Determination 2020/010

Regarding the compliance of openings in a first floor external wall with Building Code Clause F4 Safety from falling at 462 Moray Place, Dunedin

Figure 2: Wall openings (not to scale)

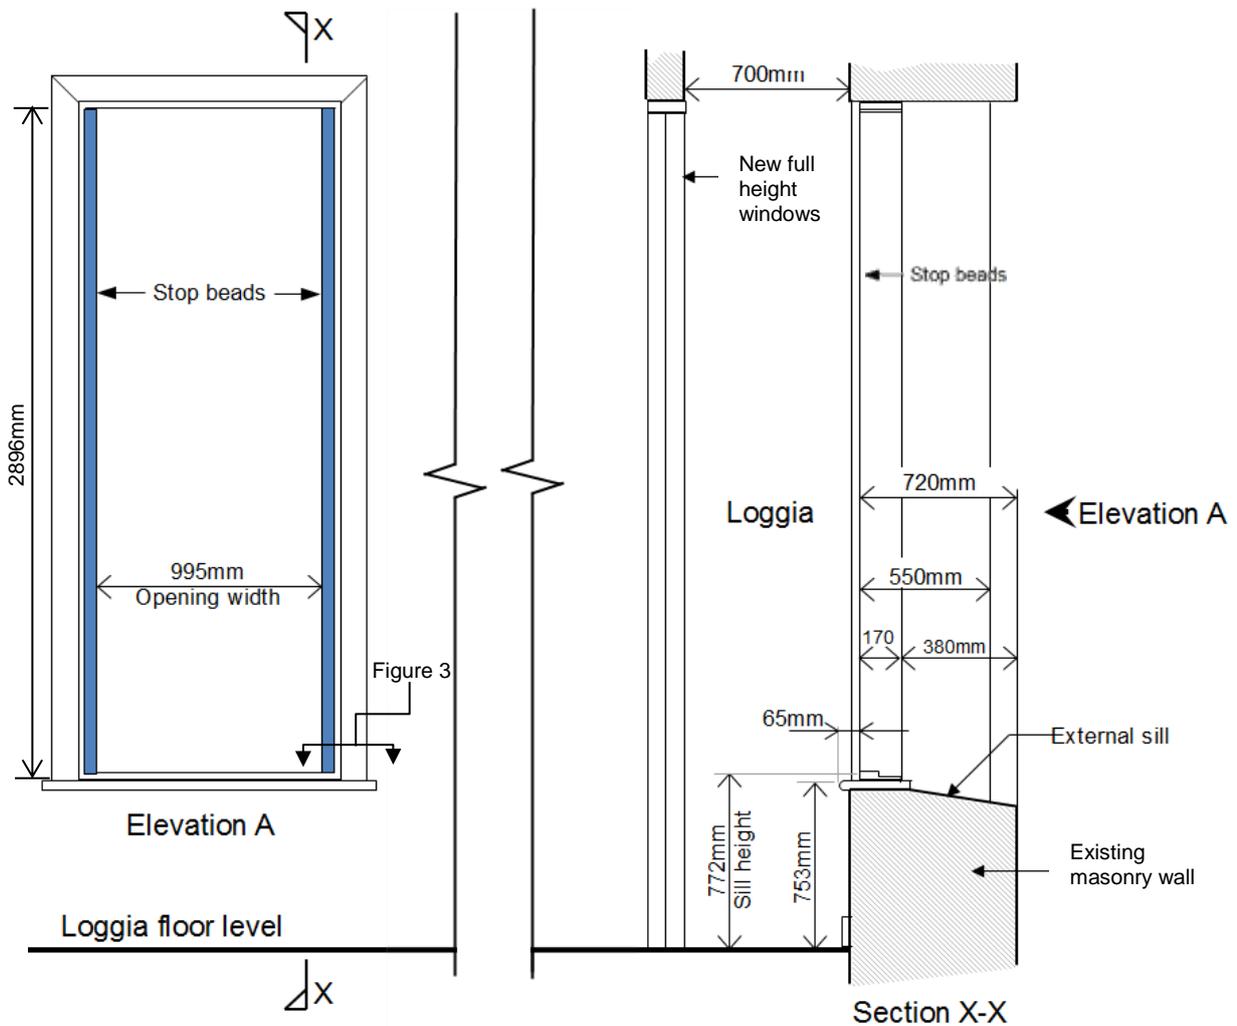
2.4 As shown in Figure 2, the height from the proposed loggia floor level to the top of the sill is approximately 772mm. The barrier to the wall opening, as it is proposed, consists of the wall below the opening and the sill. The sill has a height of 19mm and a depth of 65mm. The width of the timber frame is approximately 170mm and its thickness approximately 19mm. Formed into the wall is an external sill (“the external sill”) that slopes away at an angle for a distance of 720mm from the sill edge.

5.5.3 The barrier did not satisfy F4/AS1 because the wall opening sill height at 772mm is lower than the required 1000mm height. The low height of the barrier would likely act as a fulcrum or pivot causing a person leaning against or moving into the barrier to topple over it if that person’s centre of gravity was above 772mm (as compared with 1000mm for a barrier that satisfies F4/AS1). In other words, unless there was some feature compensating for the lack of height, the barrier does not reduce the likelihood of accidental fall and safeguard people from injury caused by falling.

5.5.4 A feature that could be seen as a factor in mitigating for the lack of height is the 720mm width of the external sill located below the top of the wall opening. If a barrier were wide enough it would not be physically possible to fall over it (as distinct from a person climbing over it). Even at some lesser width, it would be possible for a person who started to fall over it to stop their fall by putting a hand on the top of the barrier.

5.5.5 However, as shown in Figure 2 the external sill is set down from the window frame by approximately 45mm and instead of being horizontal, is sloping down and away from the building. I consider the set down and slope reduce the effectiveness of the external sill in mitigating for the lower barrier height.

5.5.6 I note no other arguments have been presented to show the barrier to the wall opening complies with Clause F4. Therefore, I am of the view that the barrier to the wall opening does not comply with Clause F4.3.4(b).

5.4.7 As I have concluded the wall openings are not “opening windows” the openings would need to satisfy Table 1 of F4/AS1, which requires a 1000mm high barrier (refer paragraph 5.3.4). The barrier height at 772mm is insufficient to satisfy F4/AS1. Therefore, compliance with Clause F4 by way of Paragraph 2.0 of F4/AS1 is not achieved.

Figure 3: Window jamb detail (not to scale)

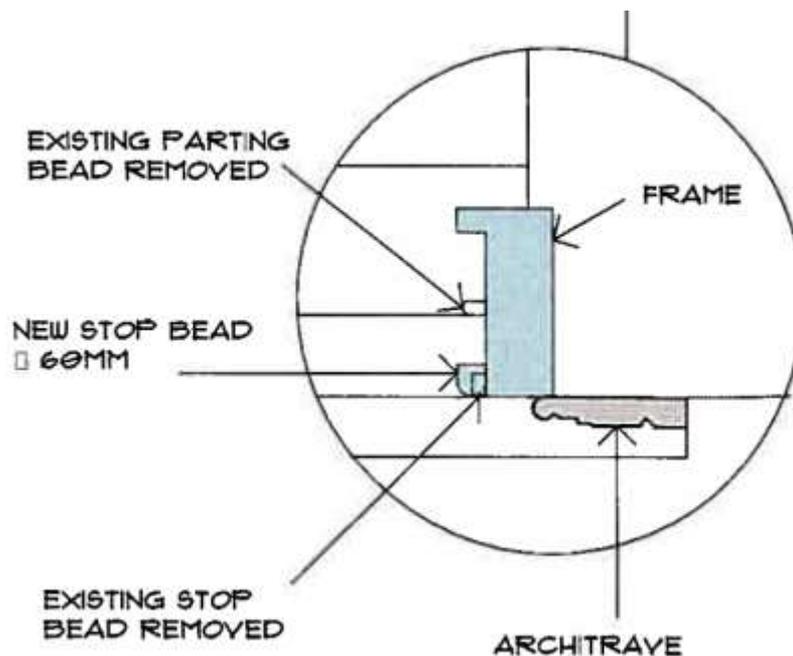
sill of the windows are to remain. The fall from the wall opening is over 1m in height. New stop beads are to be installed inside the existing frame to reduce the wall opening width to 995mm (refer Figure 3).
